UNITED STATES PATENT AND TRADEMARK OFFICE

APPLICATION NO.	FILING DATE	FIRST NAMED INVENTOR	ATTORNEY DOCKET NO.	CONFIRMATION NO.
10/655,590	09/05/2003	Peter Anthony Drake	P69121US0	7327
136	7590	04/05/2006	EXAMINER	
JACOBSON HOLMAN PLLC 400 SEVENTH STREET N.W. SUITE 600 WASHINGTON, DC 20004			ADAMS, GREGORY W	
			ART UNIT	PAPER NUMBER
			3652

Office Action Summary

DETAILED ACTION

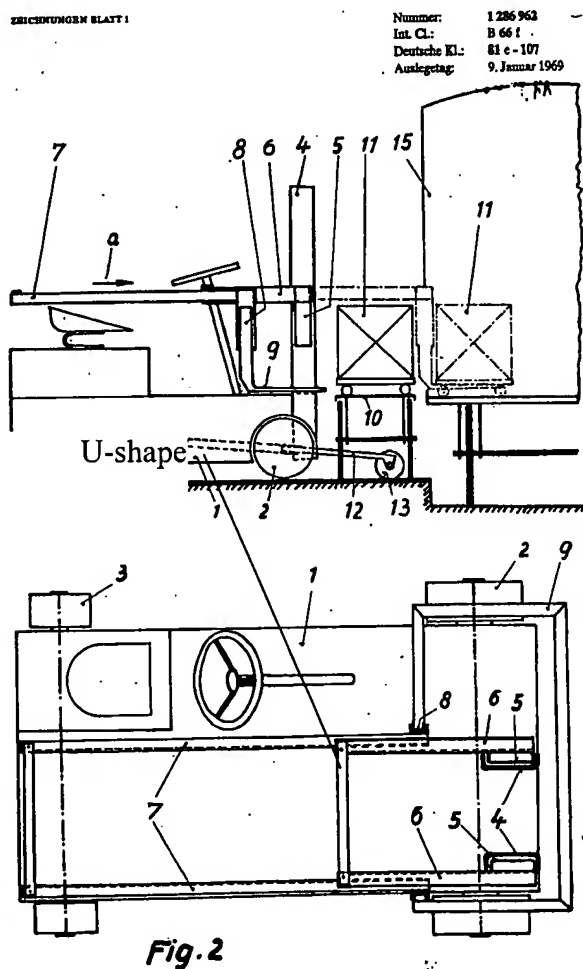
The cited prior art includes a U-shape (see FIG. 2 below), and with respect to “only three wheels”, Applicant’s invention is not limited to a particular number because the preamble does not include the language “consisting of” which would preclude any additional structure beyond that of Applicant’s. Further, arguments that the cited prior art does not have the “lifting capability” of Applicant’s is unclear because it doesn’t recite
